**Durrington Gasworks (Elizabeth Gardens Phase 2)**

**Response to Consultee Comments on Application No: AWDM/0628/26**

Our Ref: 2505550_C / Secretariat / Letters

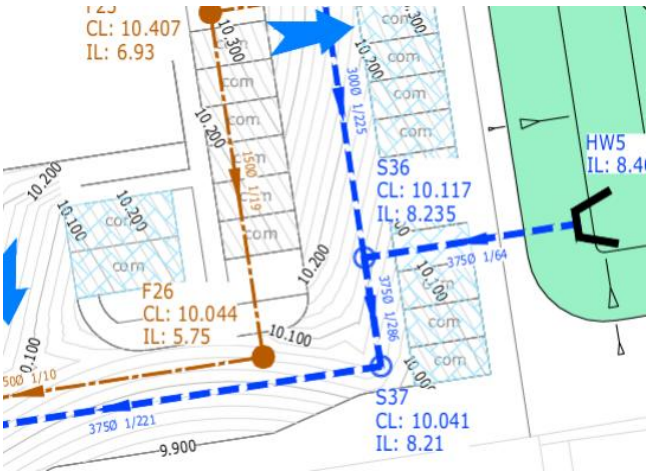
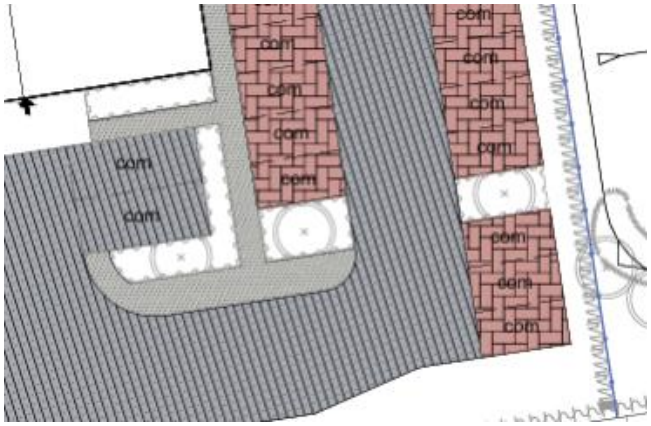
3. There appear to be conflicts between the hard landscaping drawings and the drainage strategy. For example, the drainage strategy indicates permeable paving (light blue hatching) adjacent to the industrial building; however, the corresponding area on the hard landscaping drawings is shown as concrete block paving/porous concrete block paving, although the colour distinction is unclear. To avoid ambiguity, all plans and drawings submitted under this application should be consistent and correspond with one another.

*3. The latest drainage strategy plan has been sent to the Landscape Architect to assist with coordination and permeable paving extents. See updated hard landscape proposals 7785_104-106 rev D, included within the appendices.*
